## Product Change Notification

**Product Change #: 252 Affecting 'Straight Through Tube Fittings' N410, and N210 in all materials**

**Posting Date: April 21, 2014**

N410 before change      N410 after change

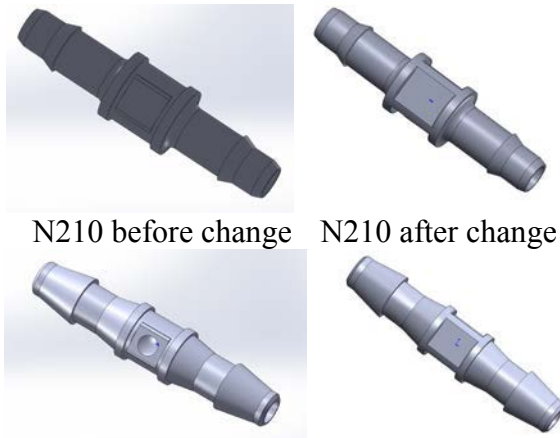
The exterior of the middle section of N410 and N210 will change from a round exterior to a square one.

There will be no change to current part numbers, materials or to the internal flow path diameter of the products.

This change was necessary to allow for automatic de-gating of the part in the manufacturing process to improve product quality.
